1 INFORMATION NOTE

2 APPLICATION SUMMARY

This is an application for a Development permit for a Material change of use (Accepted to code) to establish a Medium impact industry use (Metal forming and Plastic products) on approved future Lot 10, currently 84-160 Christensen Road South, Stapylton (more properly described as Lot 334 on SP193431).

Figure 4: Lot 10 Site Plan (Source: Multi Span Australia Design Construct)

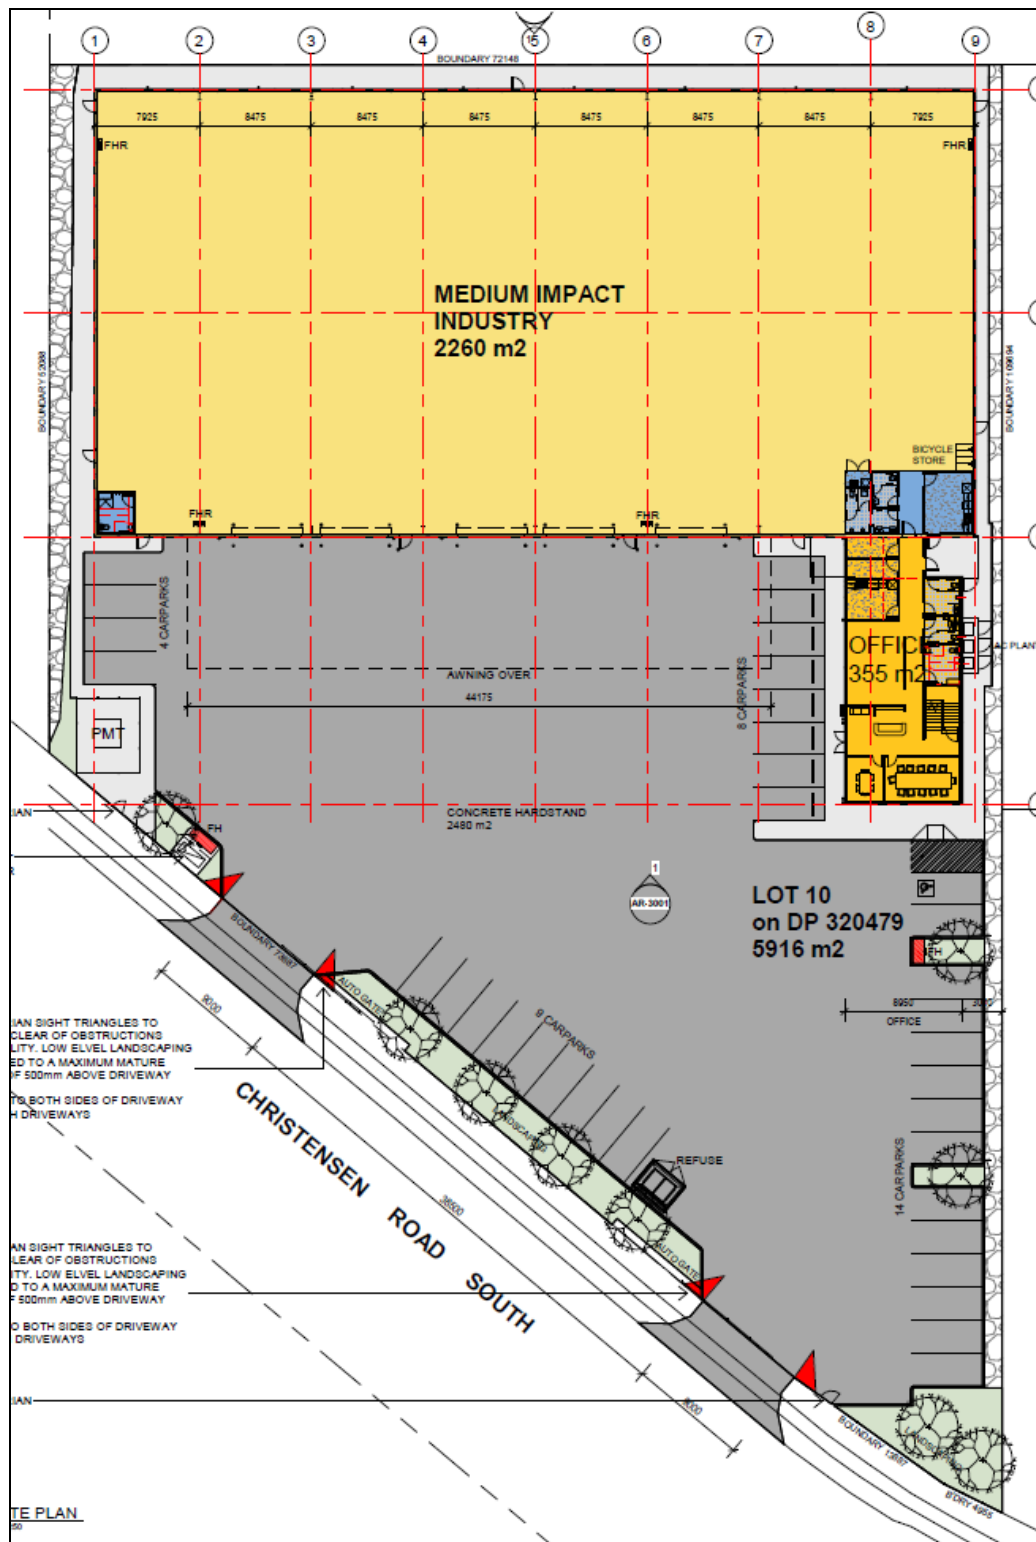
Required outcome RO8 requires landscaping along frontages to be a minimum width of 1.5m and an average width of 3m for the full width of the boundary. The proposed landscaping does not achieve a consistent minimum width of 1.5m or the average width of 3m and must therefore be assessed against the applicable Performance outcome.

Landscaping is provided along the entire frontage to Christensen Road South. While there are pinch points where car parking hardstand touches the frontage boundary, the gardens proposed are sufficient to accommodate a variety of shrubs and trees at regular intervals to provide a quality interface with the streetscape to soften the built form, suitably screen the industrial uses, and enhance the visual amenity of the area. Conditions have been provided to ensure that a minimum 8 trees are accommodated within the frontage. Officers consider that there is suitable space for 4 trees within the central garden area between the two crossovers, or alternatively, that an additional tree could be accommodated adjacent the refuse area while maintaining suitable separation from the booster cabinet and remaining outside of the sight triangle.

To meet Required outcome RO2 of the Transport code, the development must not have gateways, doors or similar devices which restrict vehicular access to car parking spaces for employees and visitors. Development drawings show security gates restrict vehicular access. The proposed development therefore does not meet Required outcome RO2 of the Transport code and must be assessed against .

To meet Required outcome RO4 of the Transport code, the development is required to provide a minimum of 18 bicycle parking spaces for staff, however, the proposal includes four (4) bicycle parking spaces for staff. The development therefore cannot comply with Required outcomes RO4 and RO7 and must be assessed against Performance outcome PO7 of the Transport code.

To meet Required outcome RO10 of the Transport code, off street car parking area must be designed in accordance with Australian Standard AS2890.1.

Officers recommend a condition of approval is imposed requiring the security gates to remain open during the operating hours to ensure the subject is functions efficiently and car parking spaces are available during the times the development is operating.

Officers are recommending a condition of approval which requires car parking bays and pedestrian sight triangles to be fully dimensioned in accordance with the relevant requirements of Australian Standard AS2890.1:2004.

Figure 8: Elevations (West and South) (Source: Multi Span Australia Design Construct)

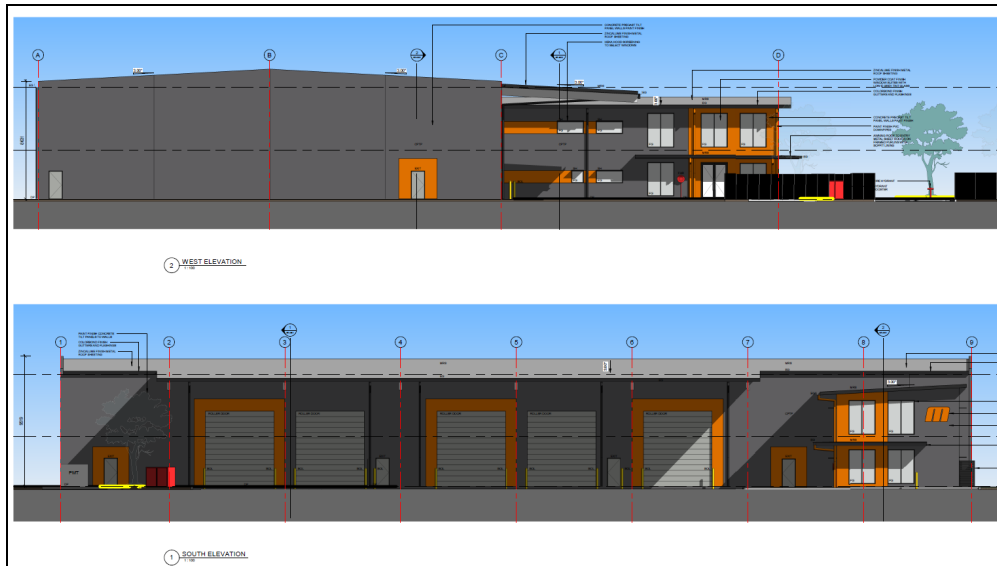
The proposed development does not incorporate sufficient variation in the parapet design or roof height every 10m on the walls facing the primary street frontage, further the building composition does not contain sufficient variation in colour scheme or materials. The proposal must therefore be assessed against Performance outcome PO1 of the Industrial design code.

Officers contemplate that the proposed design promotes a high quality industrial area considering the character of the locality, however, Officers are concerned that the western wall, which does not contain a high level of accent elements, will be visible from the street front through the adjoining car park on adjoining approved future Lot 9. Officers are therefore recommending conditions which require the proposed accent details to be provided, and also requires additional accent details on the western wall (or an outcome in line with Required outcome RO4).

Based on the above assessment, and subject to conditions, it is considered that the development complies with Performance outcome PO1 of the Industrial design code.
